S73 MINOR MATERIAL AMENDMENTS

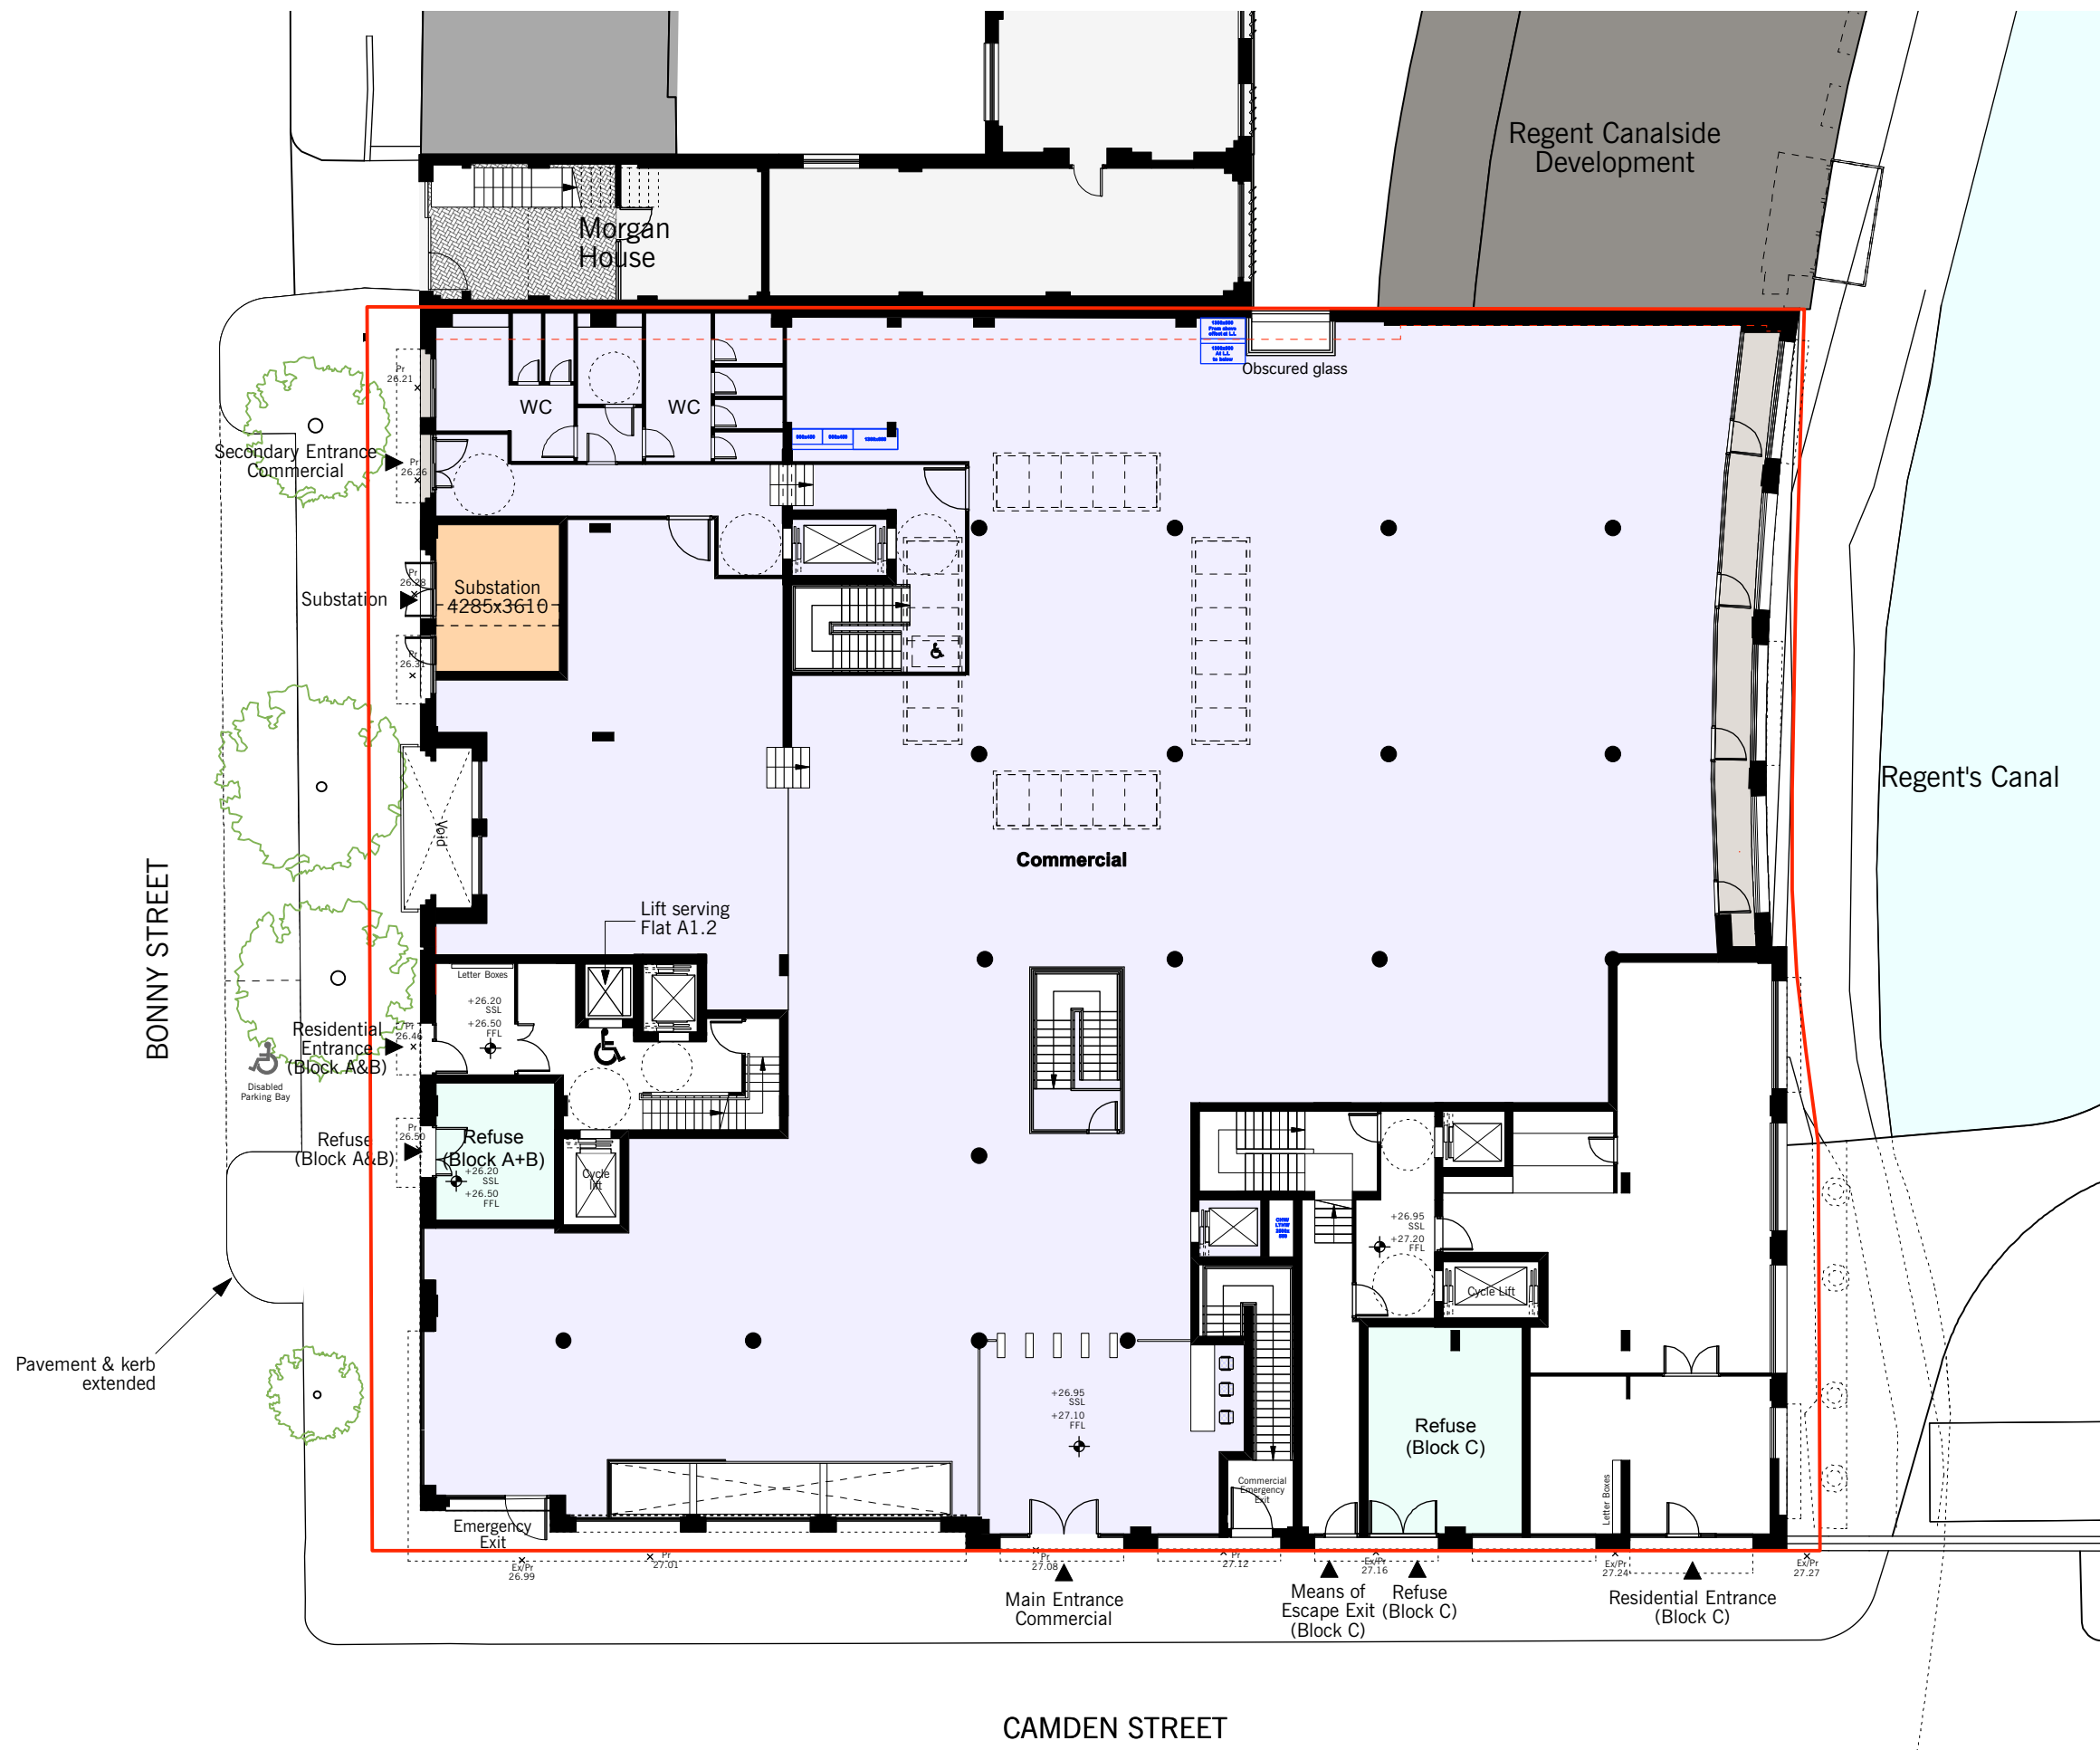
Rev.K 20/06/2019:

- 1.RESIDENTIAL:
  - R.1) Lift serving Block A omitted
  - R.2) Block A cycle store repositioned to lower ground floor.
  - R.3) Block C cycle store and cycle lift repositioned, staircase amended.
  - R.4) Wheelchair unit repositioned to first floor, lift serving wheelchair unit indicated
  - R.5) Block C entrance repositioned, entrance hall amended, staircase amended, refuse store repositioned.
- 2.COMMERCIAL:
  - C.1) Staircases repositioned, passenger lift added, general revision to accord with the amendments to staircases.
  - C.2) Floor voids omitted.

Rev.L 01/08/2019:

- 1.RESIDENTIAL:
  - R.1) Entrance/means of escape doors revised.
- 2.COMMERCIAL:
  - C.1) Emergency exit doors and secondary entrance door revised.
